Product change

Correction of data sheets for EPCOS PM coil formers produced in Šumperk

Product / Process Change Notification

Type PM50/39

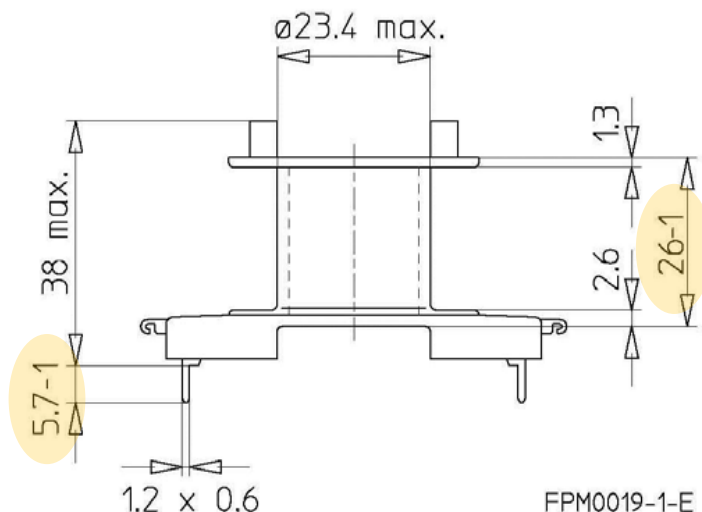
The data sheets for EPCOS PM coil formers produced by the Šumperk plant, Czech Republic, have been revised to the actual value (tolerances for two dimensions) of the products. The products themselves remain unchanged.
